ADDENDUM NO. 1

Schertz Seguin Local Government Corporation

Contract 3 - 36" Pipeline

October 27, 2020

A1 CONNECTION DETAIL (SHEET C100)
N.T.S.

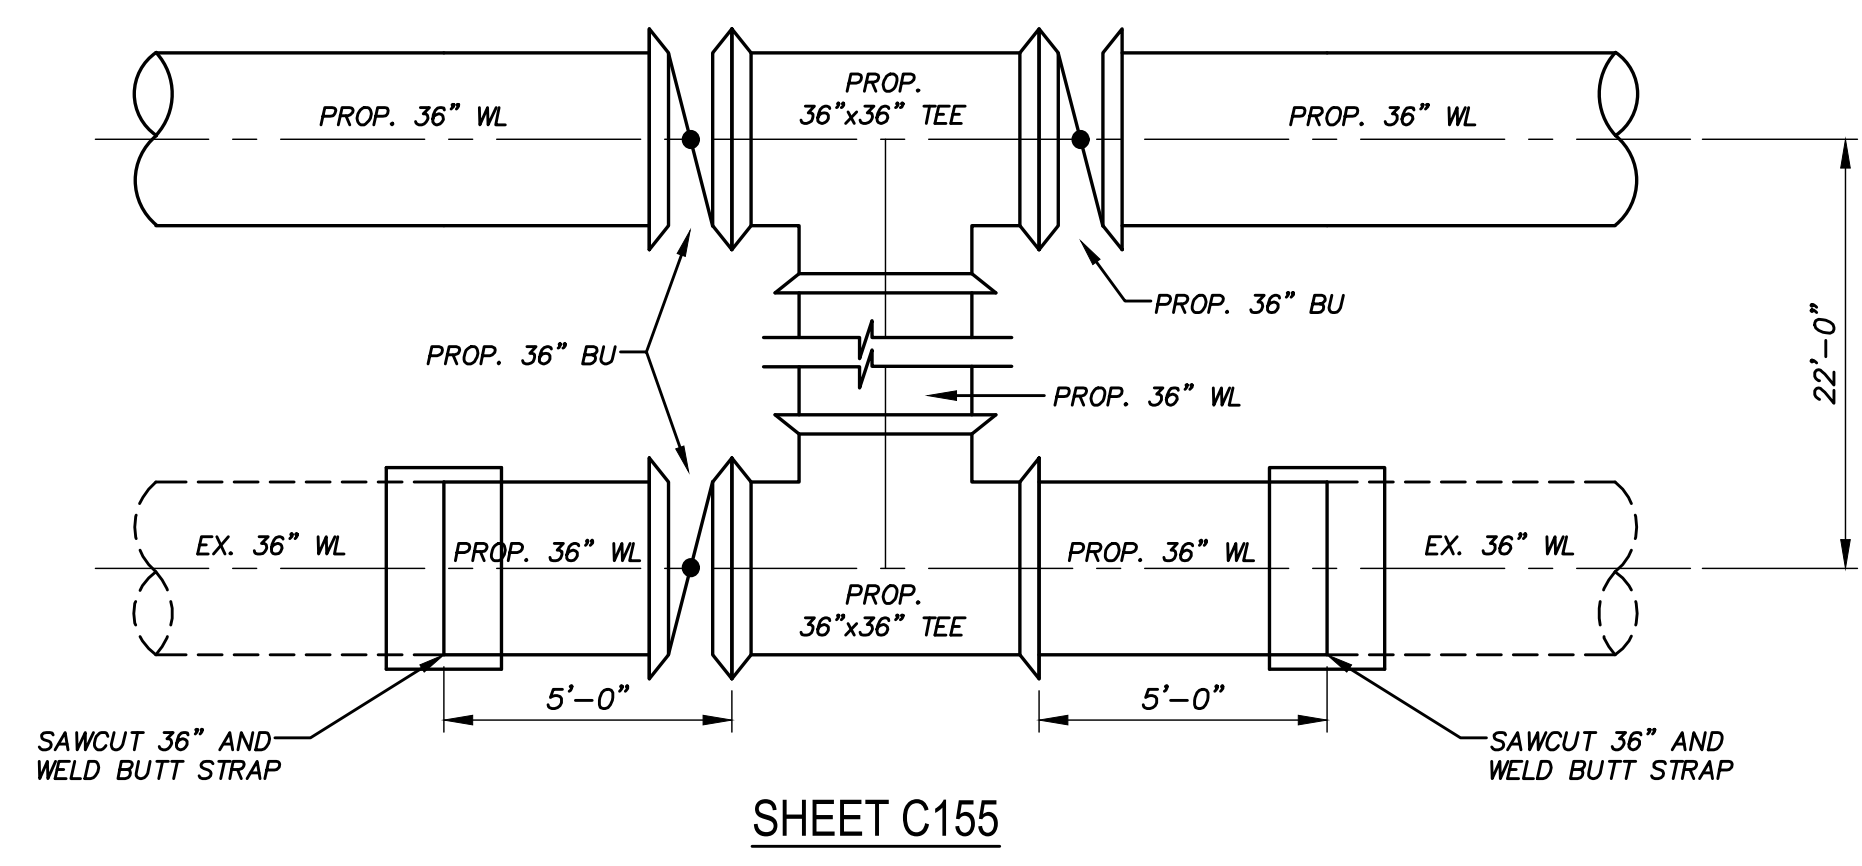
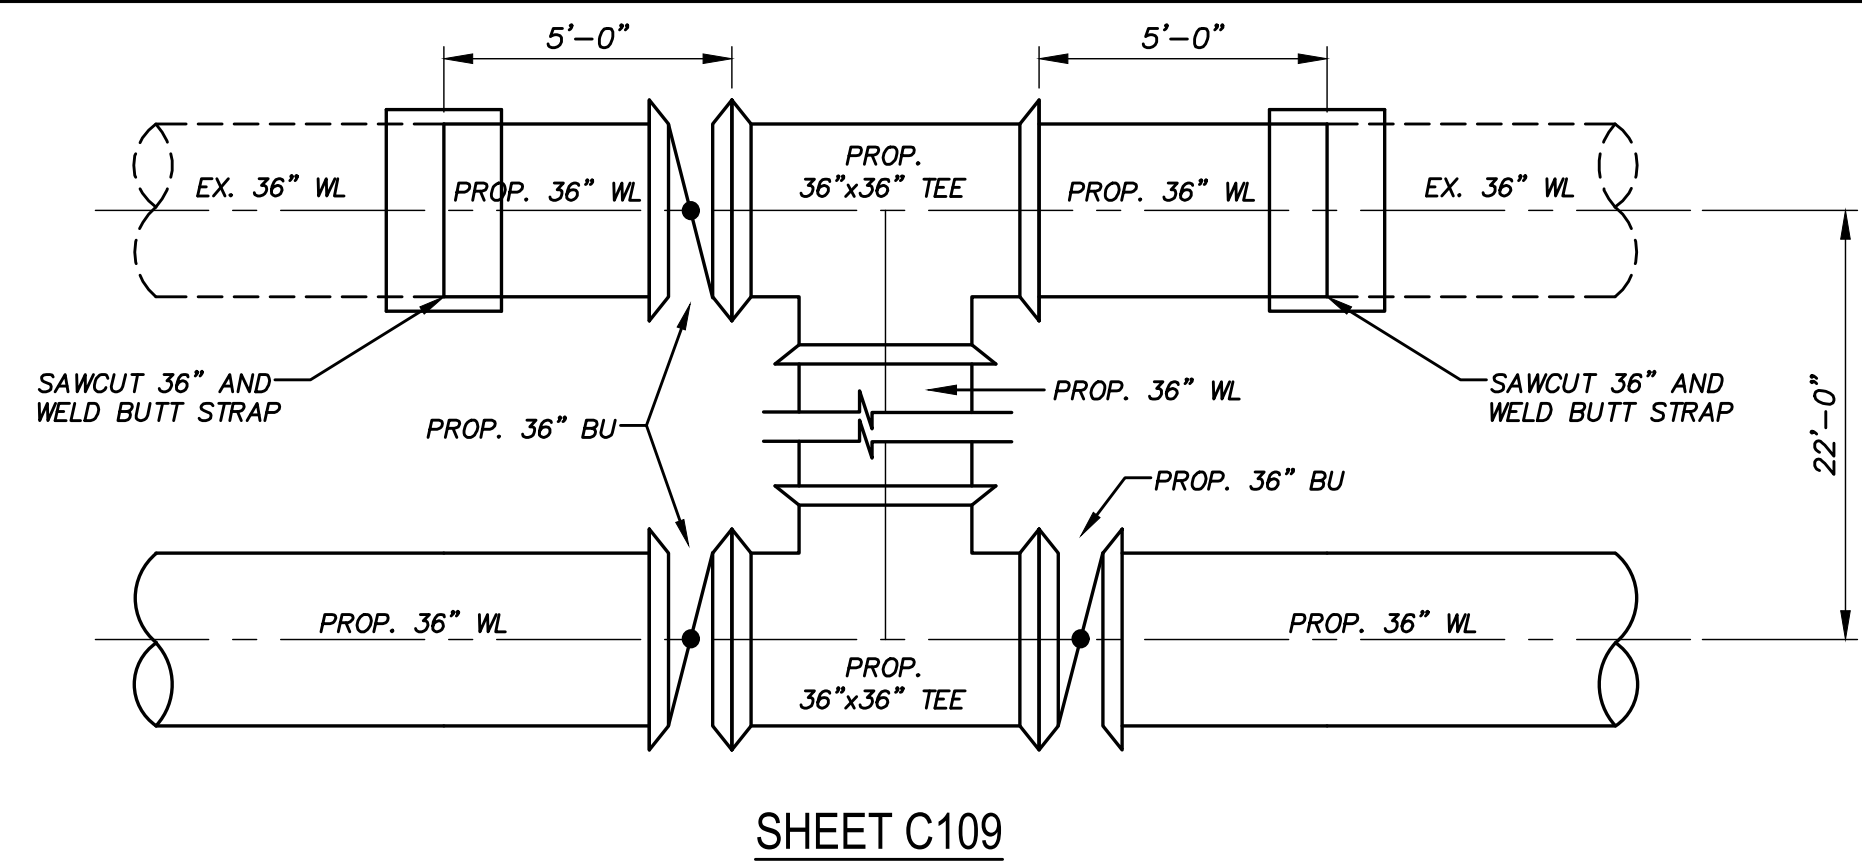
9. Sheet D201. 4” Assembly Combination Air Valve Detail (Item 27 of the Proposal Form) is hereby amended. Use the attached detail for this Project.
10. Sheet D301. Butt Strap added to Detail A1.
